November 14, 2022

ADDENDUM NUMBER 2
TO THE DRAWINGS AND SPECIFICATIONS

PROJECT: Lincoln Central Elementary School HVAC Renovation

A/E PROJECT NO: 25821422

PROJECT #	25821422
ISSUED DATE	10/25/2022
SHEET	A803
OF SHEETS

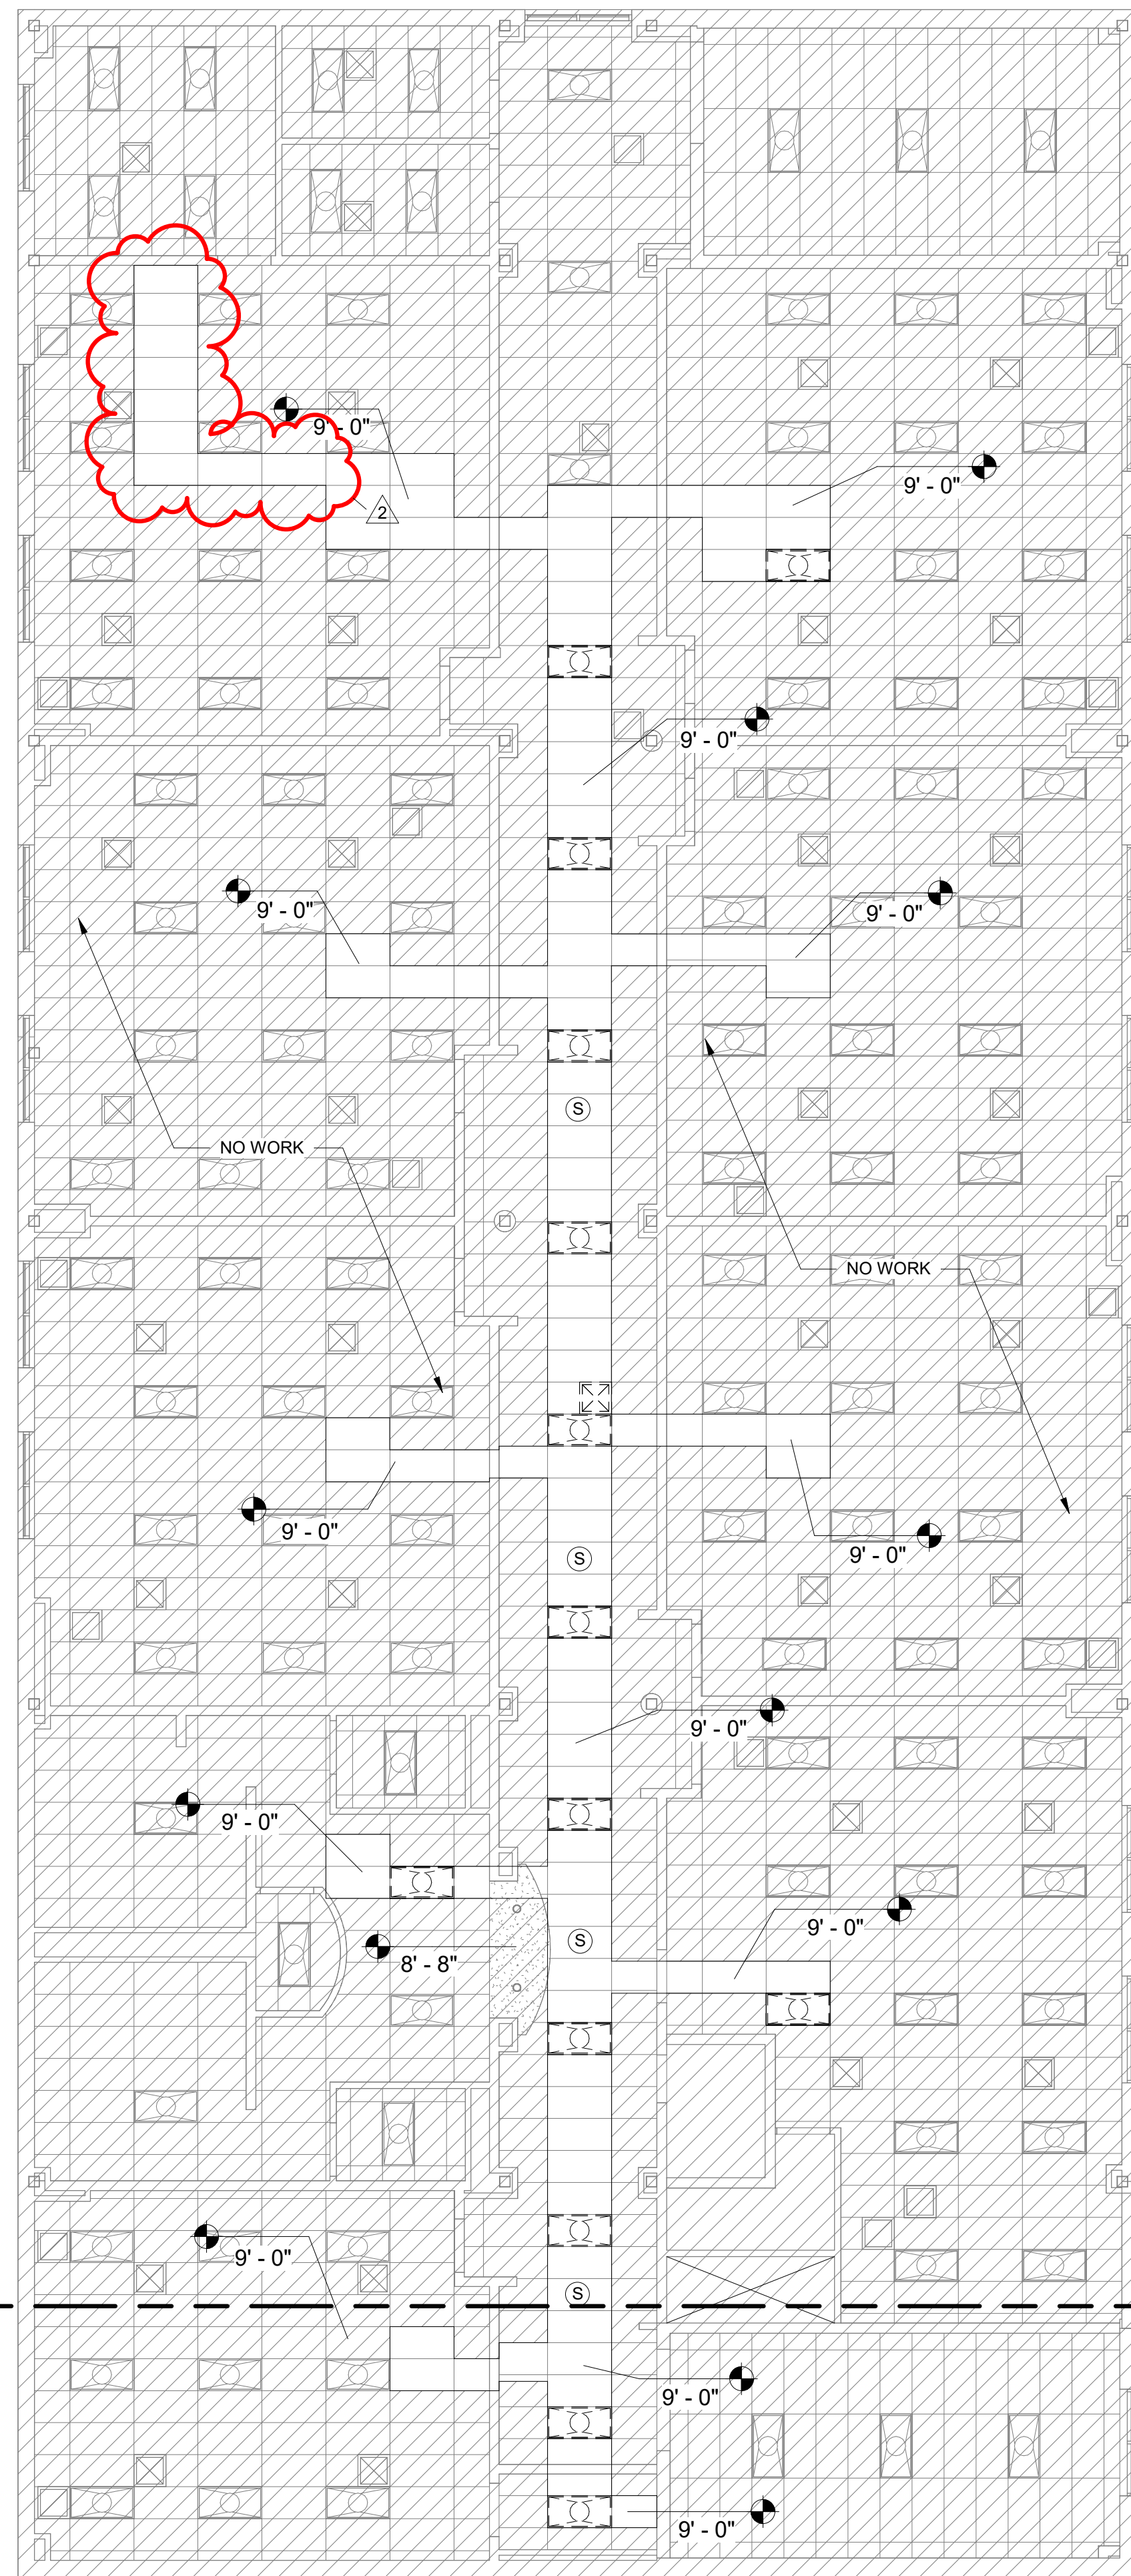
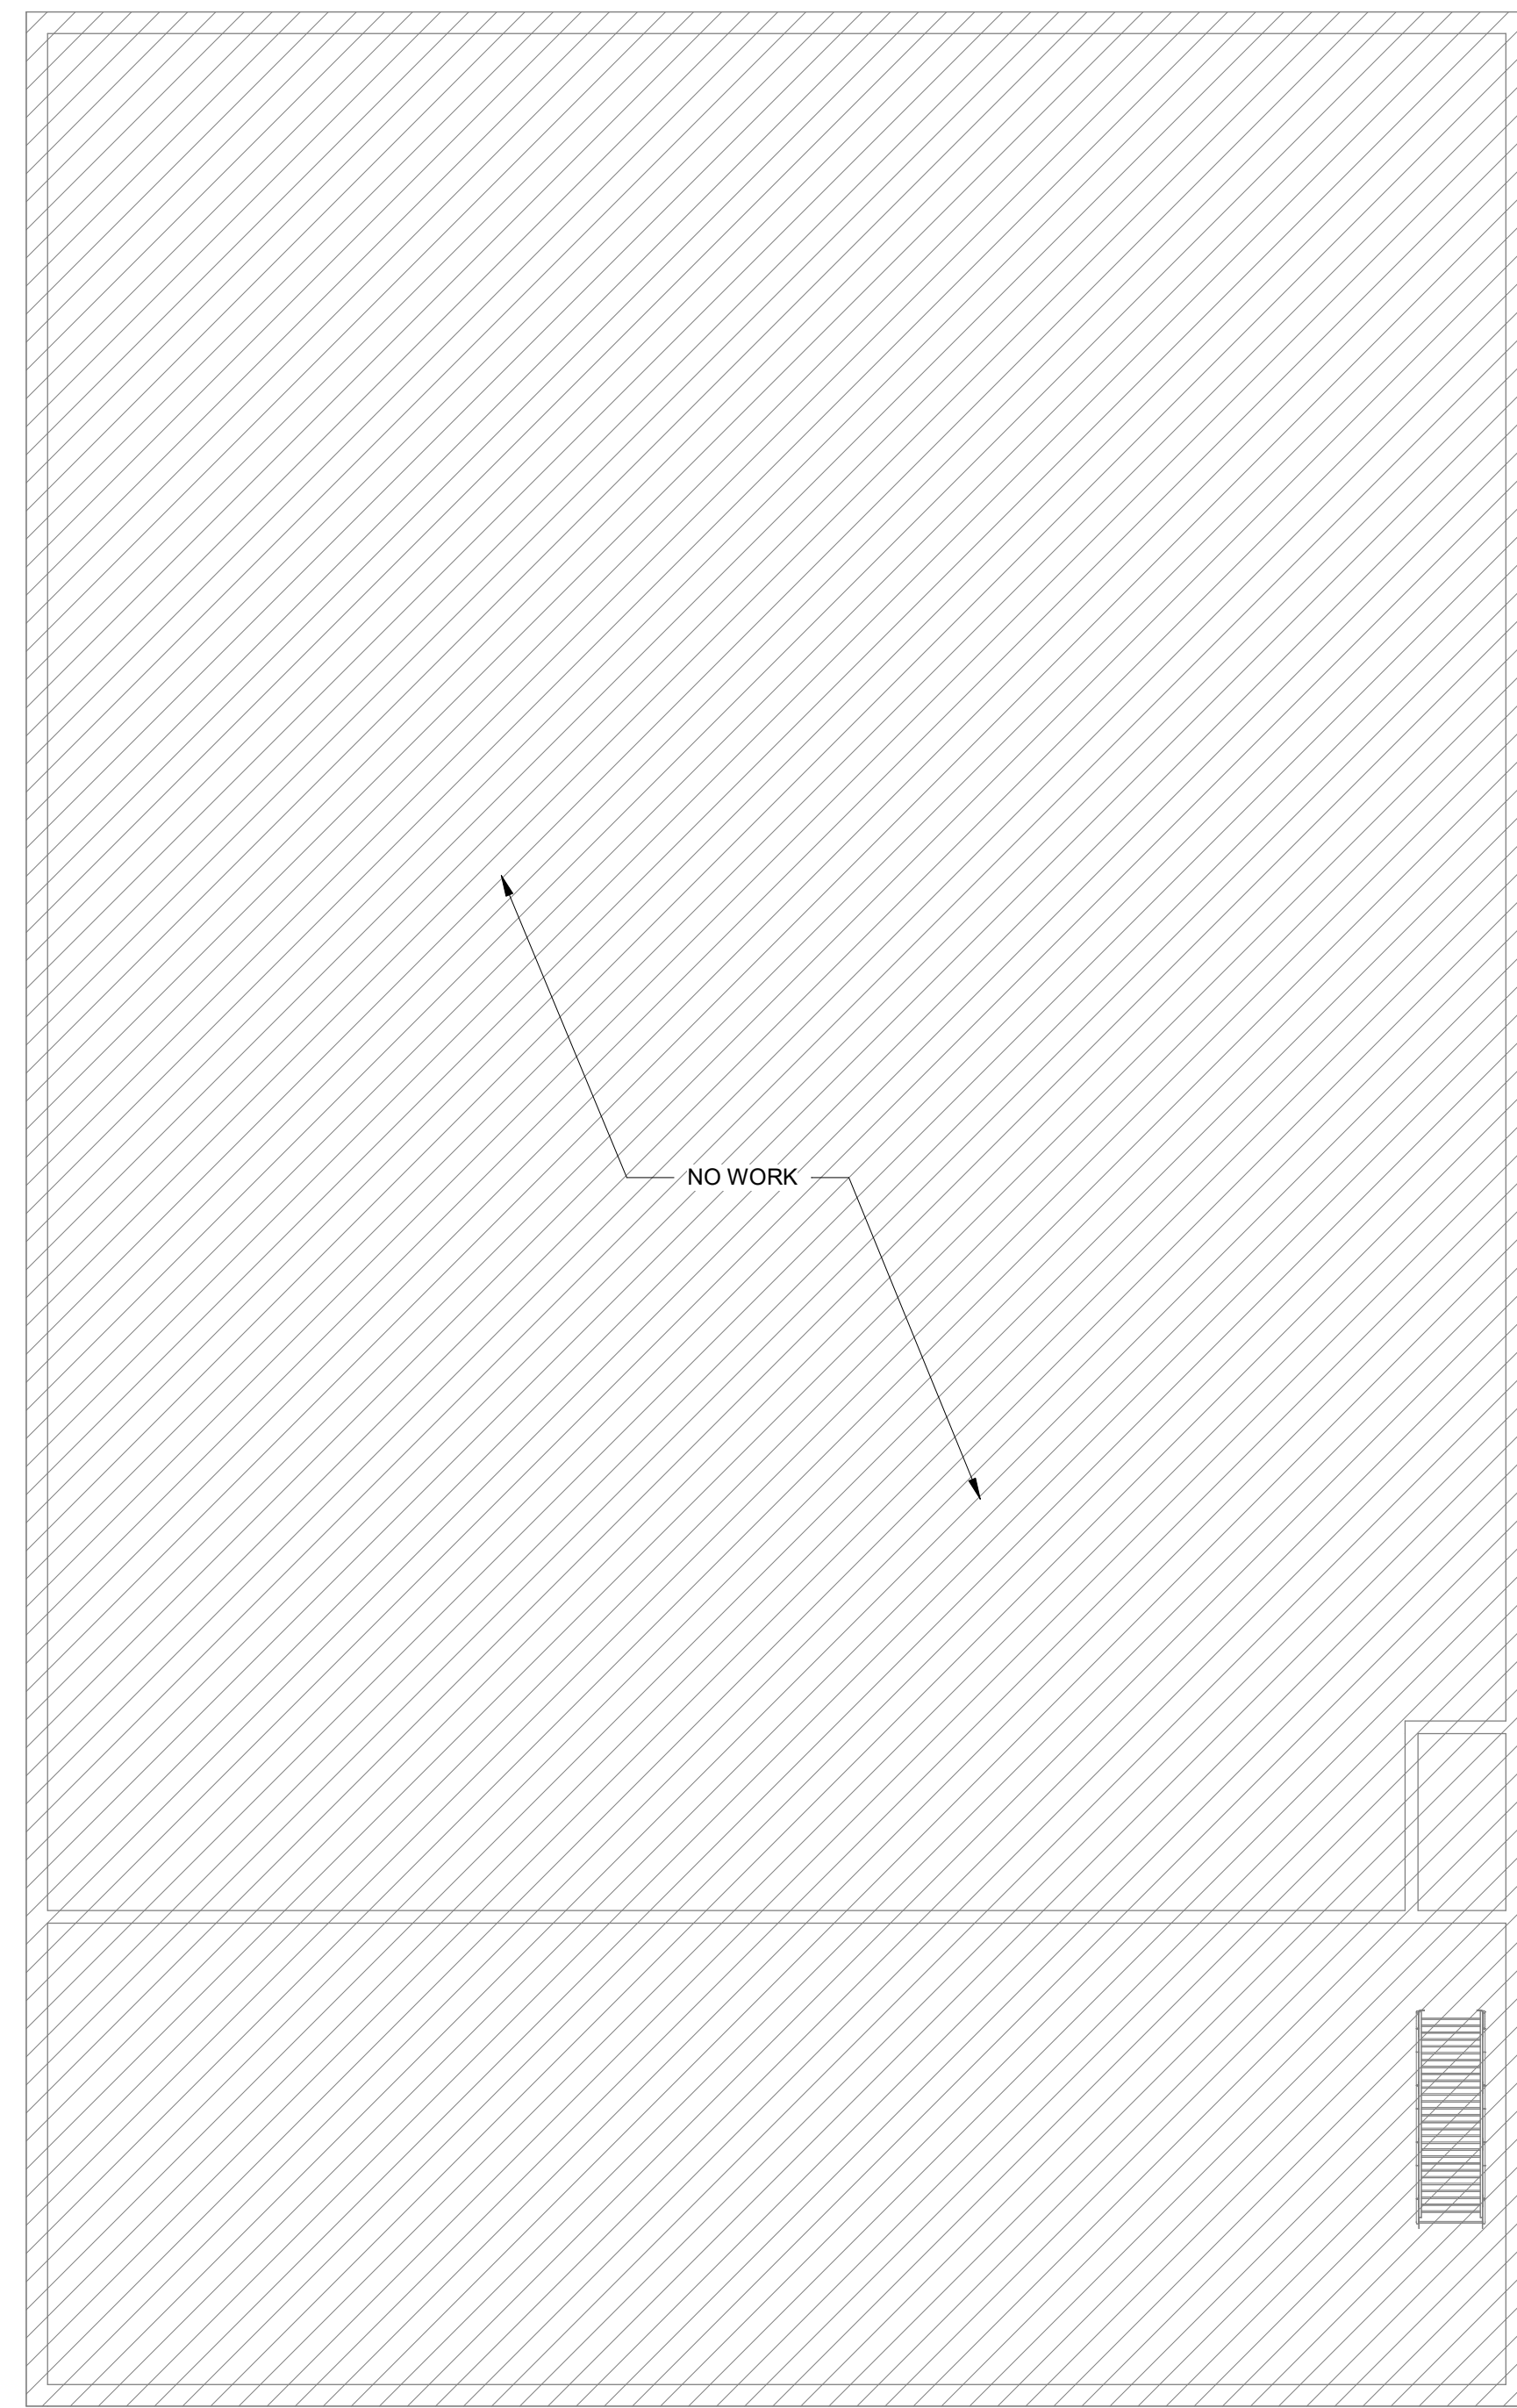
10. TO THE DRAWINGS; Sheet A801 & Sheet A803: Add ceiling removal and

replacement as shown on new A801 and A803 sheet.

11. TO THE DRAWINGS; Sheet M1.2: Delete original Sheet M1.2. Replace with attached Sheet M1.2.
12. TO THE DRAWINGS; Sheets A801, A802, and A803: With the ceiling removal shown, there may be 2 security cameras to be reinstalled and 12 exit fixtures reinstalled.
